Queries raised by prospective tenderers for In-floor Pit jacks

A. TECHNICAL

GENERAL LAYOUT OF THE ROLLING STOCK

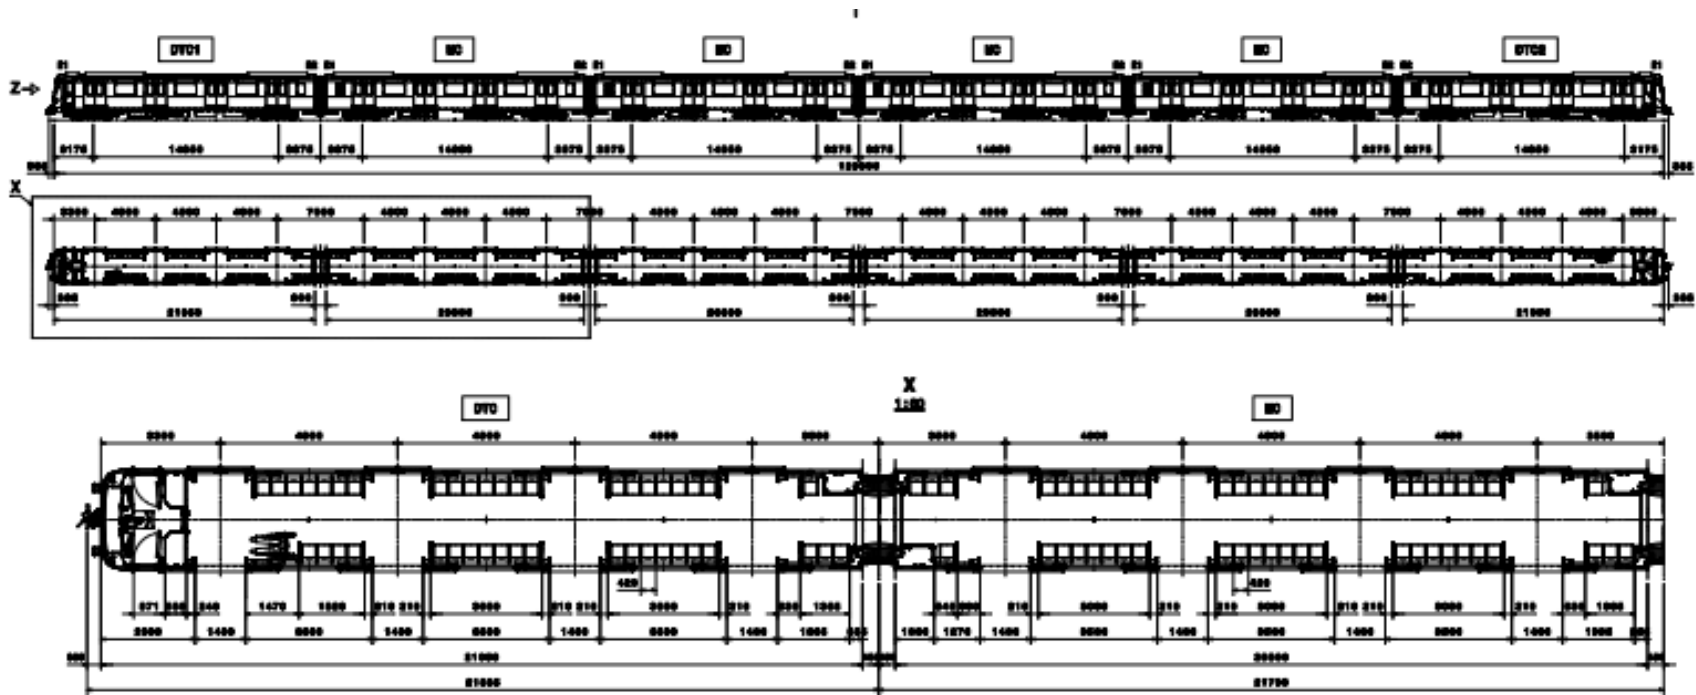
mentioning, make, country of origin, parts numbers, catalogues etc.	certificates during FAT? If the supplier has to wait for Engineers approval before procurement, then the delivery may be delayed.		
7	2.18 of PS	Principal Notional Vehicle Dimensions*	<p>There are missing the most important measurements for the car body support pads:</p> <p>Length and width of pads</p> <p>Distance of pads from each other from center to center</p> <p>Distance of lifting pads from top of rail</p> <p>Distance between pad and center of bogie.</p> <p>Please provide.</p> <p>A drawing of the train configurations (2-/3-coupled) with all dimensions would be very helpful.</p> <p>Furthermore it is not clear which minimum/maximum dimension of bogie wheelbase and distance between bogie centers belong to which car (DT or M?)</p> <p>It would be helpful to list up all dimensions separately for DT and for M-car.</p> <p>The distance from front of DT/M-car to the first center of bogie is also missed.</p>	<p>The detail dimension of pad etc are interface issues between the RS & the tenderer. However, the General Unit Arrangement Drawing of the Train is being provided which will show all the major dimensions.</p> <p>Dimensions are marked either for DT or M car. Where not provided those are common for DT &M.</p>	Not required
